From: Bill Reed [REDACTED]
Sent: 23 May 2017 15:42
To: Enirayetan, Oluwaseyi
Cc: ERNEST JAMES; Richenda Walford
Subject: Application number: 2017/2481/A 345 Gray's Inn Road LONDON WC1X 8PX

IMG_3623

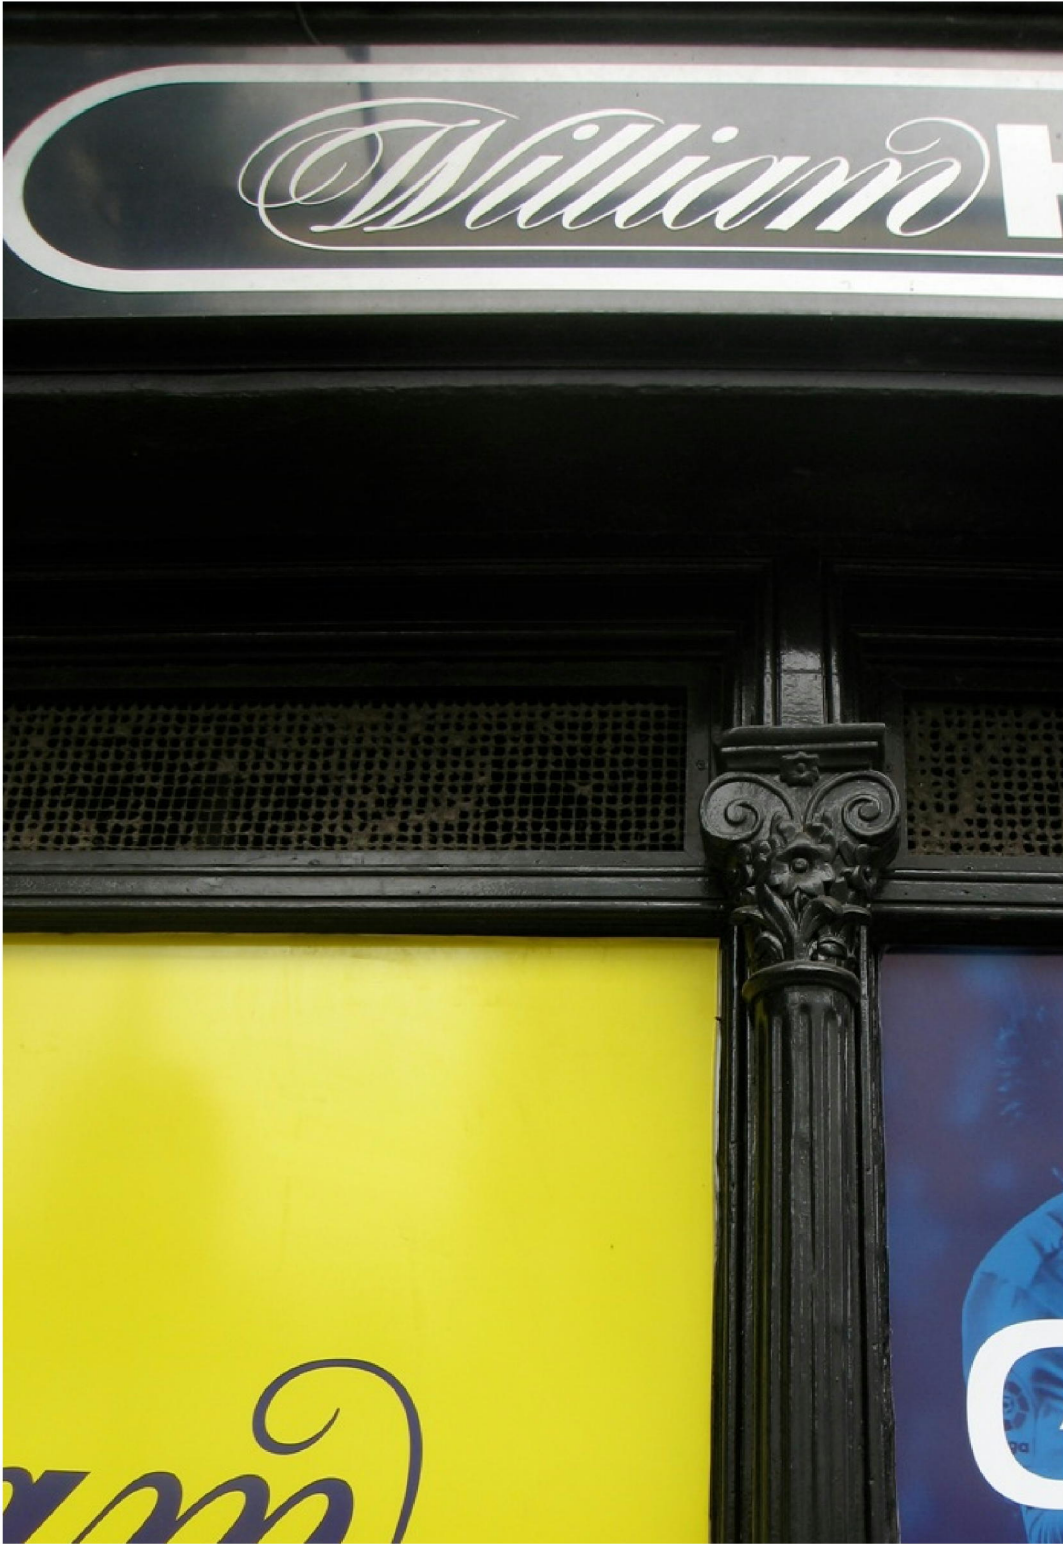
Please can I object to this application on behalf of the Kings Cross CAAC? The building is on a very prominent corner of the Kings Cross Conservation Area, and the ground floor benefits from what would have been an attractive shopfront, with many of the details still remaining (see below). Unfortunately William Hill have covered all the glazing with vinyl advertising (see below) that seriously detracts from the building as a whole and is visible across King's Cross Square - as no doubt it was intended to be. This advertising does serious harm to this important part of the Conservation Area, and we urge you to refuse consent. The application also contains revisions to the fascias, and while this is hardly an improvement, it causes little damage.
